ADDENDUM TO RFP DOCUMENTS

ADDENDUM #01

Solano Community College District Vacaville Center HVAC Upgrade Project Project #18-010

Date: February 12, 2018

(SK-1) EXTENDED PARAPET DETAIL

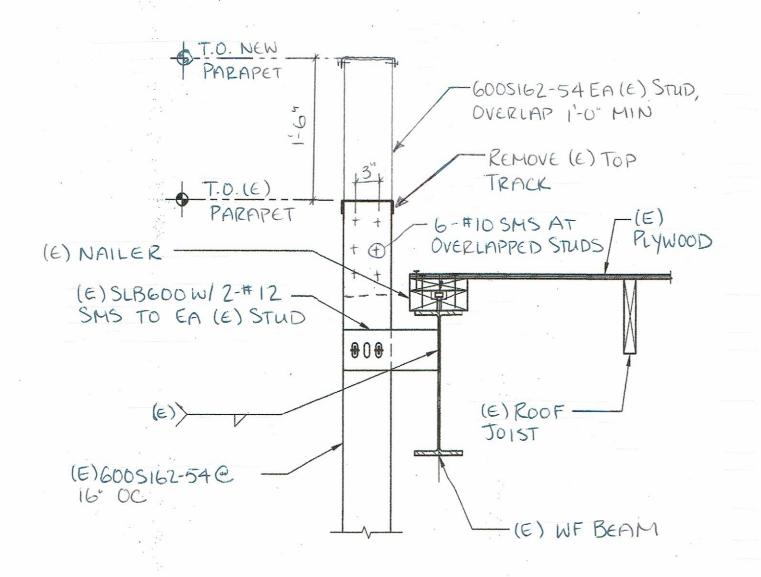
Sheet A4.3 has a hand written note to extend parapet wall to achieve min. 42".

Please provide a structural detail to extend the parapet wall that includes roofing and flashing.

Extend the existing parapet per the attached SK-1.

2ND FLOOR NORTH REFLECTED **CEILING PLAN**

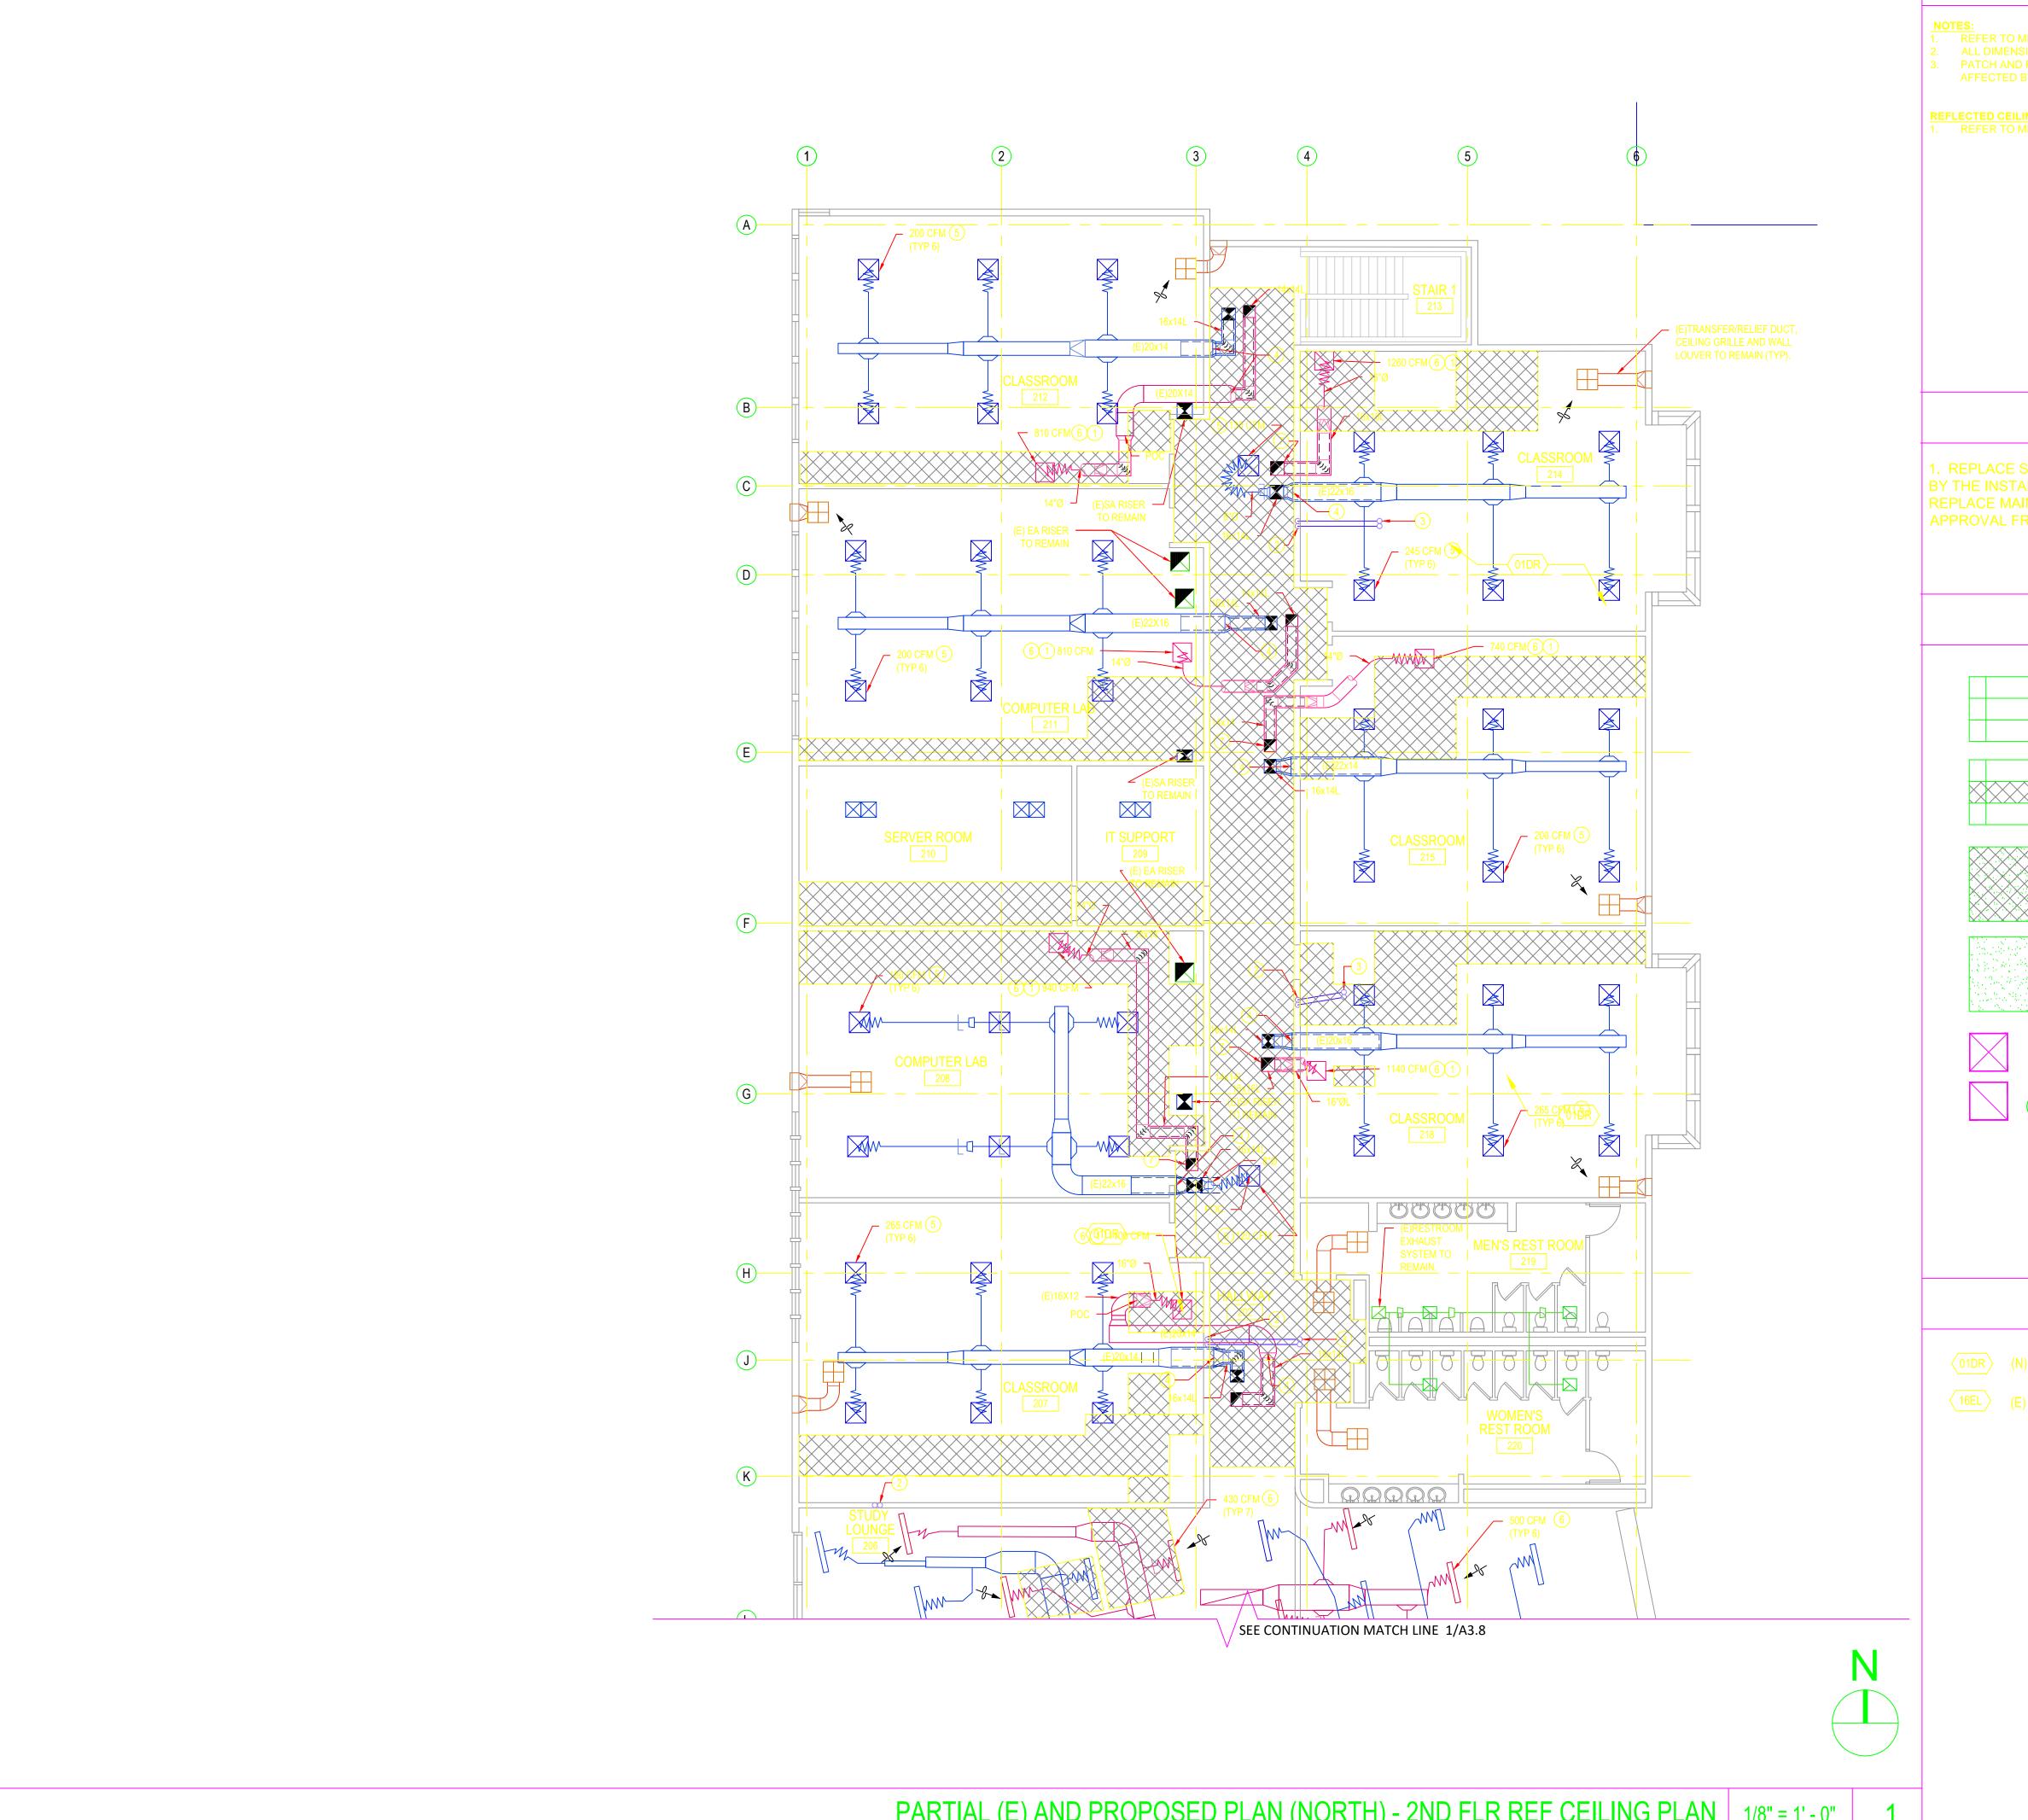
The second floor North and South reflected ceiling plans shown on A3.7 & A3.8 are identical to the second floor North reflected ceiling plans shown on A3.3 & A3.4

Please provide the corrected sheet showing the new work.

WLC ARC	CHITECTS, INC.				
REVIEW COMPLETED DO NOT RESUBMIT	REVISED AS NOTED, RESUBMIT FOR RECORD				
REVISED AS NOTED DO NOT RESUBMIT	NOT ACCEPTABLE MAKE NEW SUBMITTAL				
see attached F	PDF				
AREVIEW IS ONLY FOR GENERAL CONFORMANCE WITH DESIGN CONCEPT AND CONTRACT REQUIREMENTS. CONTRACTOR IS RESPONSIBLE FOR COMPLIANCE WITH CONTRACT DOCUMENTS, DIMENSIONS, QUANTITIES, FIT AND COORDINATION WITH OTHER WORK. REVIEW DOES NOT AUTHORIZE SUBSTITUTIONS, EXCLUSIONS AND LIMITATIONS TO CONTRACT REQUIREMENTS UNLESS SPECIFICALLY REQUESTED BY CONTRACTOR AND ACKNOWLEDGED BY ARCHITECT.					
BY: WLC	_{DATE:} 2-9-2018
